# Memo

**Subject:** OPA-17/ZBA-11-22 - 51 & 57 Sandwich Street S, Public Meeting Summary

**MIXED USE DEVELOPMENT**  
CONCEPTUAL DEVELOPMENT PLAN

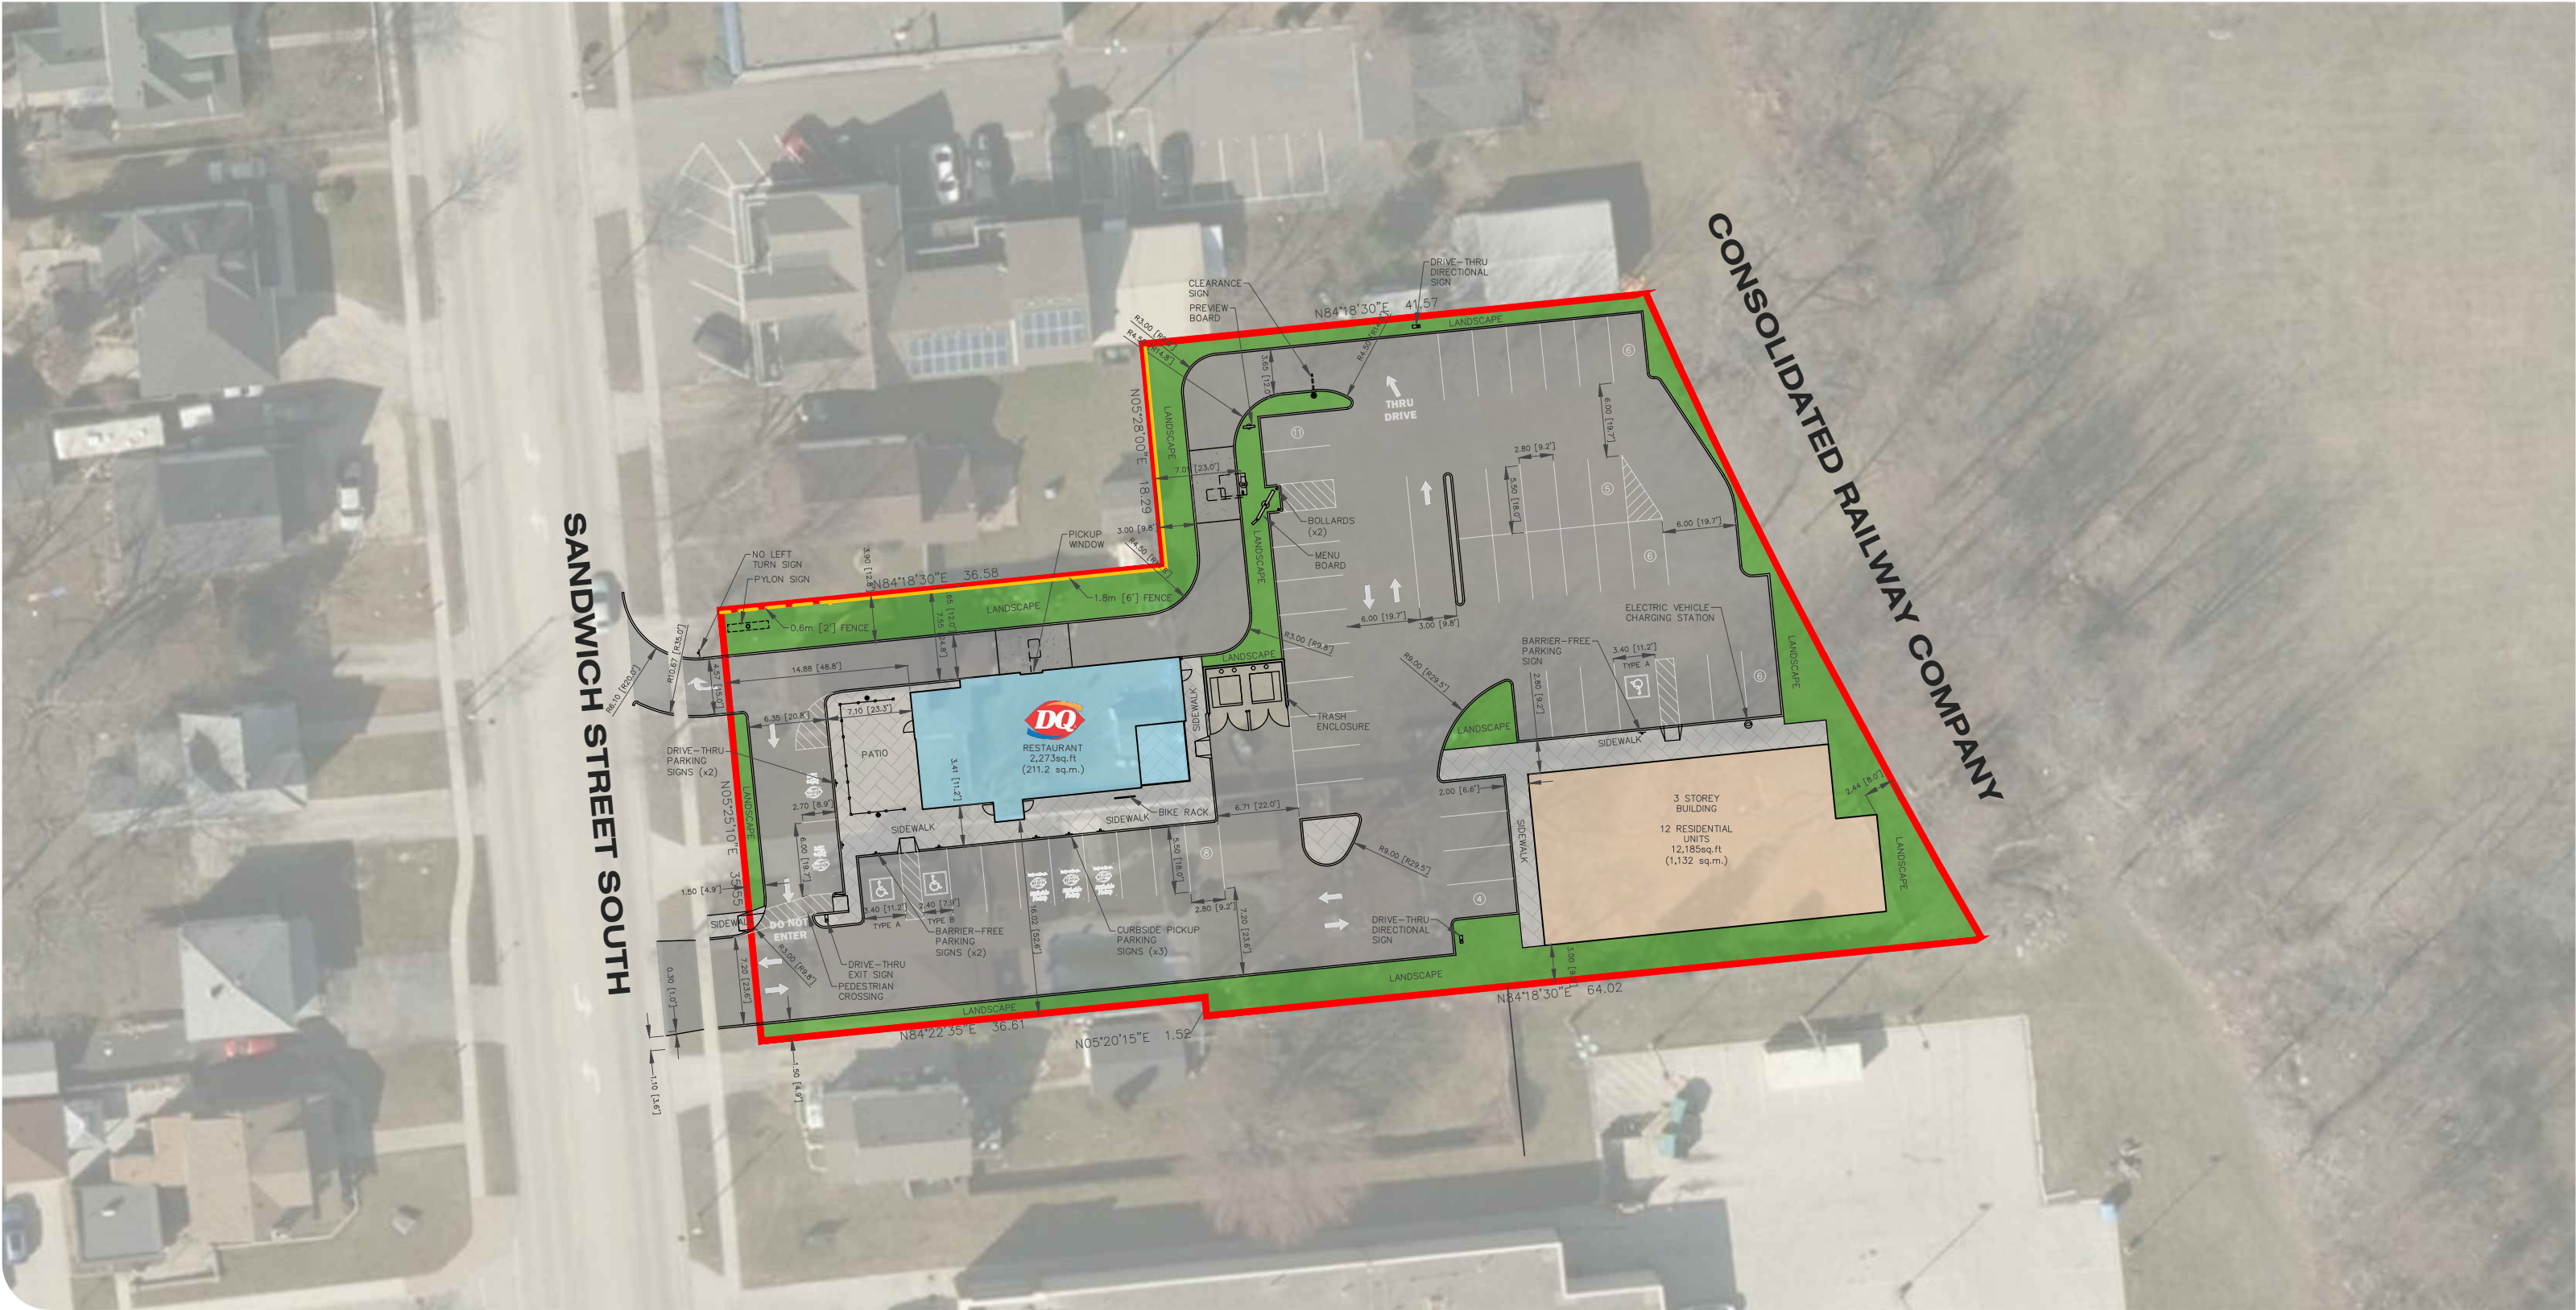
Comments	Response
<p><b>Traffic:</b></p> <ul style="list-style-type: none"> <li>Concerns about traffic problems already existing in the area and the potential for increased traffic</li> <li>Recommendation by municipal staff to add a 'Right-out' exit for the drive-through to reduce the number of vehicles exiting the site at the primary access</li> <li>Concern that the drive-through will create traffic conflict and back-ups onto Sandwich Street South</li> </ul>	<ul style="list-style-type: none"> <li>A Transportation Impact Study (TIS) and addendum was submitted as part of the OPA and ZBA application. The assessment documented existing traffic volumes and traffic projections for the driveway under existing conditions and with the proposed development, utilizing transaction data from proxy DQ sites. It also looked at on-site circulation, and intersection capacity under existing and future conditions. The TIS concluded that the study area intersections and the proposed driveway are projected to operate in an acceptable manner through to the 2028 horizon year and that no modifications to off-site infrastructure or traffic control are needed to support this development.</li> <li>This comment has been noted. A 'right-out' access has been included in the updated Conceptual Development Plan dated July 13, 2022 (see attached).</li> <li>The proposed development provides for ten (10) drive-through queuing spaces. Zoning By-law 1999-52, as amended, requires a minimum of 6 spaces. In addition, the parking lot can accommodate an additional 10 to 11 vehicles.</li> </ul>

Comments	Response
<p><b>Heritage:</b></p> <ul style="list-style-type: none"> <li>Concern regarding the design of the mixed use/residential building as it was not available at the time of the Public Meeting</li> <li>Concern regarding the landscaping features</li> <li>Request that the fence design be circulated to the Heritage Committee</li> </ul>	<ul style="list-style-type: none"> <li>This concern has been noted. The development proposal has been updated to confirm that the building in the rear of the property will have twelve (12) residential units and will not have a commercial use on the ground floor. Elevations will be provided to the Heritage Committee for the proposed building for their review.</li> <li>At the outset of the project, the Heritage Planner for the Municipality was consulted on the proposed development. The design of both the DQ and the residential building have taken into account the recommendations from the Heritage Planner, including façade updates on the DQ model from EIFS to Hardi Board</li> <li>The Applicant will continue to work with the Municipality and DQ throughout the site plan approval process to finalize the renderings for both the restaurant and the residential building that will complement the heritage character of the Town. This will include façade treatments, building materials, and accents.</li> <li>A Landscape Plan and Details will be provided to the Municipality as part of the Site Plan Control process.</li> </ul>

Comments	Response
<ul style="list-style-type: none"> <li>Concerns over noise from the patio late into the evening</li> </ul>	<ul style="list-style-type: none"> <li>The proposed fencing and landscaping will bring additional buffering elements and further reduce any impacts to the neighbouring residential dwelling.</li> <li>The hours of operation for the DQ will be from 10am to 10pm (Noon to 10pm on Sundays). For the summer months (May through August), it will be open until 11pm on Saturdays and Sundays. It should be noted that the kitchen closes at 10pm, with few customers between 10pm and 11pm.</li> <li>Fencing (6ft) and landscaping are proposed adjacent to the abutting property to increase privacy and to mitigate potential noise from customers using the patio.</li> </ul>
<p><b>Active Transportation:</b></p> <ul style="list-style-type: none"> <li>Recommendation to include bike racks and pedestrian cross-section to encourage active transportation and reduce drive-through use (idling)</li> </ul>	<ul style="list-style-type: none"> <li>This comment has been noted. A bicycle rack for seven (7) bicycles and a pedestrian crossing have been included on the updated Conceptual Development Plan, dated July 13, 2022 (see attached).</li> </ul>

We have given careful consideration to the comments received from the public, Council, and municipal staff and have incorporated these recommendations into the revised conceptual development plan. We feel the potential impacts of the built form in relation to the existing uses along the Sandwich Street commercial corridor have been addressed and will be compatible with the surrounding land uses.
